ADAPTABLE HOUSING REPORT

AMOEBA ACCESS PTY LTD

Project: Block 9 Section 132, Casey ACT 2913
Document Type: Adaptable Housing Assessment Report
Our Reference: P2024_1604-4 (Adaptable Housing Report) YW

Figure 1 – One bedroom apartment type 1 (pre/post adaptation)

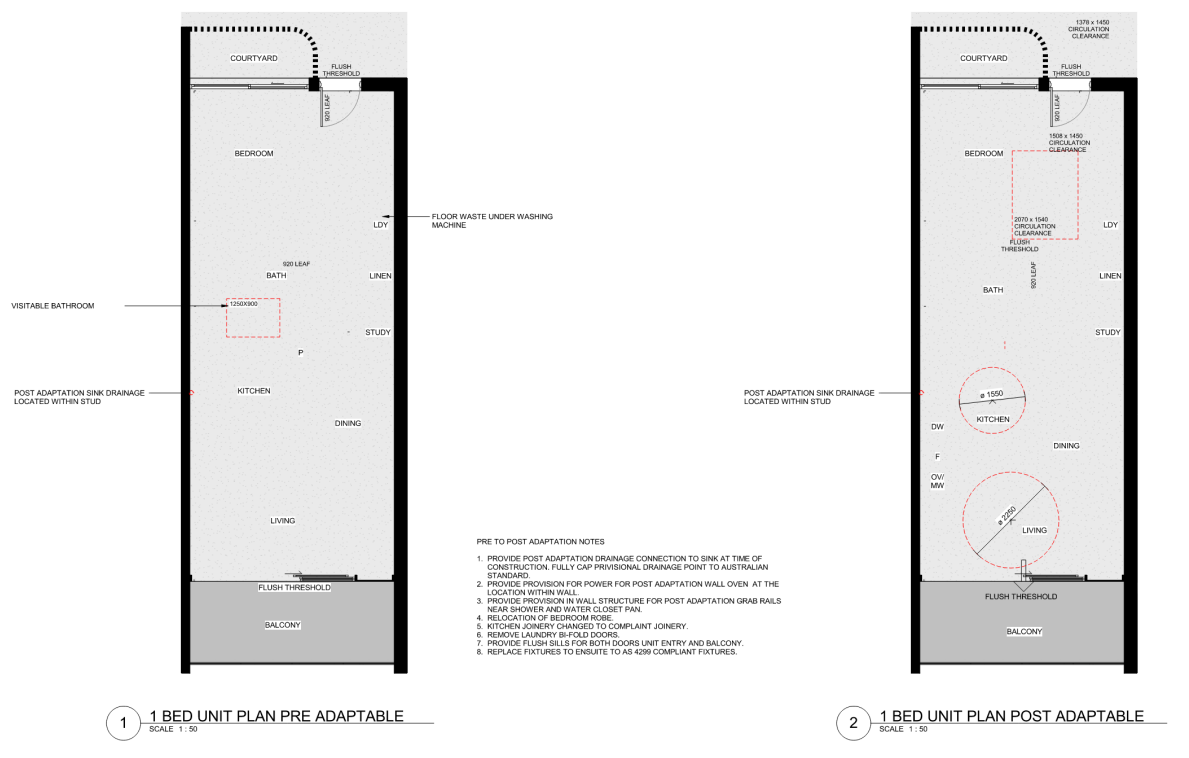
The kitchen bench for the one bed and three bed units needs to be readjusted to allow a 800mm-900mm wide accessible bench top with oven and cooktop to be placed on either side of the accessible bench top, please refer to the markups for details.

Note that provisional plumbing is required for the relocation of the kitchen bench for both the 1 bedroom and 3 bedroom units.

Figure 2 – Two bedroom apartment type 2 (pre/post adaptation)

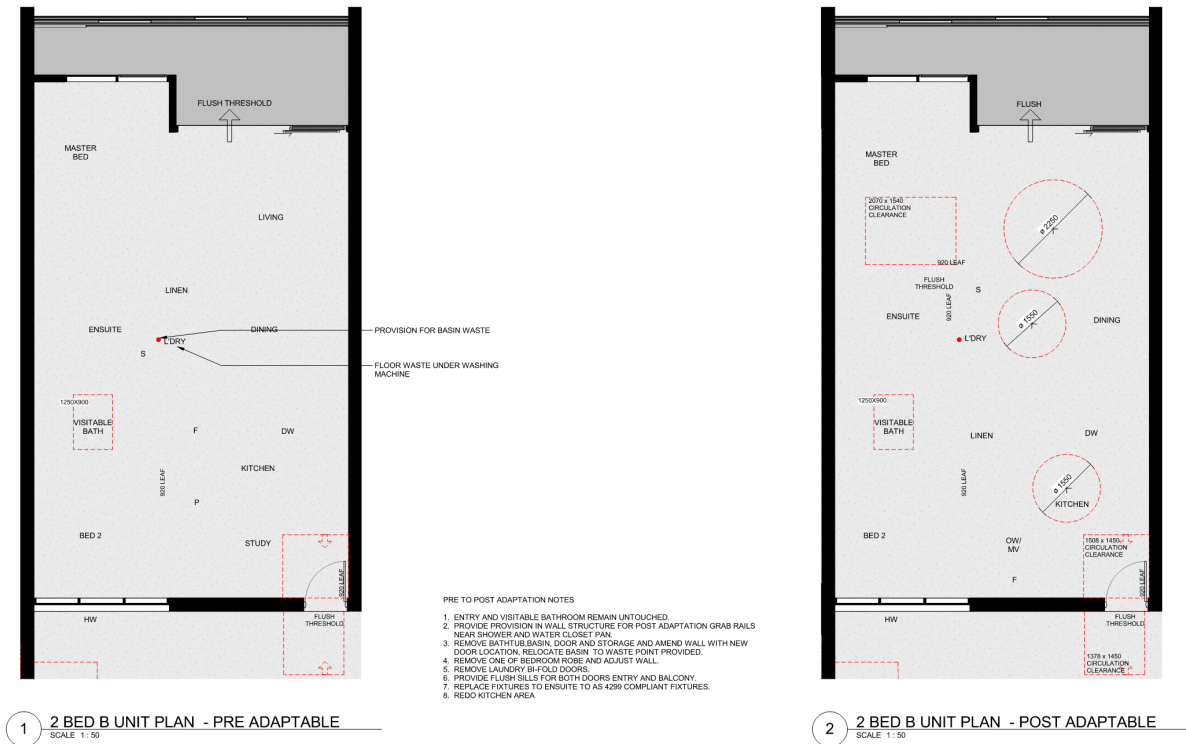
Note that provisional plumbing is required in the bathrooms for both 2 bedroom and 3 bedroom units.

Figure 4 – Proposed continuous accessible pedestrian access route

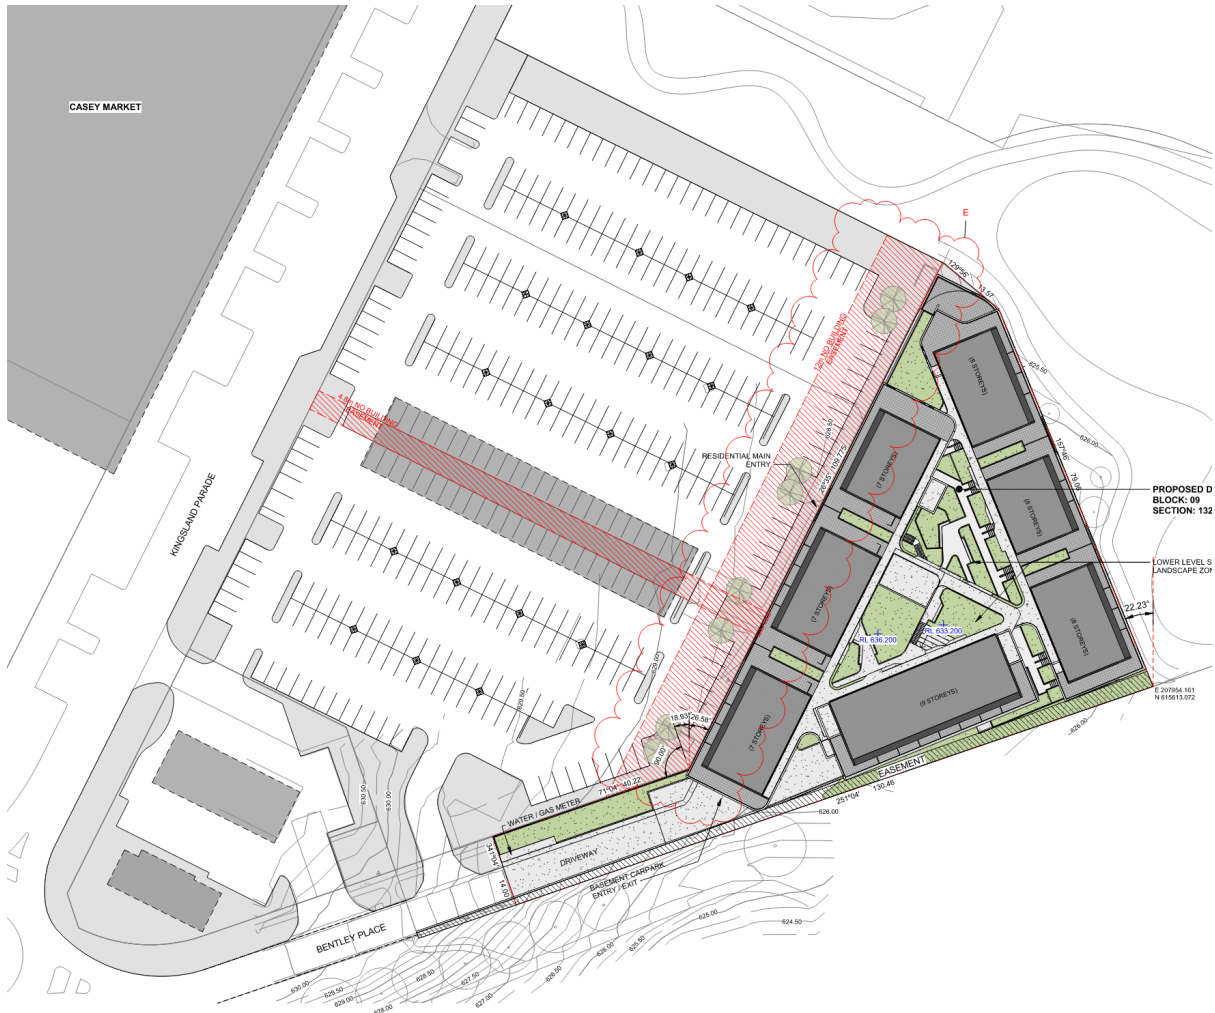
At the current stage of the design development, it is unclear as to how the existing public council footpath merges with the new pedestrian entries of the development in regards to levels. Details are to be addressed as the development progresses to Building Approval stage noting that 1:20 gradient and crossfall of 1:40 shall be achieved.
